# GAIAA SAIAA

# 2023-24 Design, Build, Fly Q&A #5

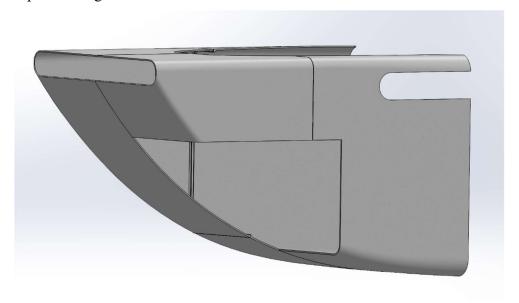
4. Can the floor insert be touching the internal walls of the aircraft, or can it only touch the floor?

Answer: The insert must be on the floor so that the payloads are on the floor. Any additional features to secure, locate, or mount the insert inside the airplane are at each team's discretion including touching or attaching to the inner walls or other features of the airplane.
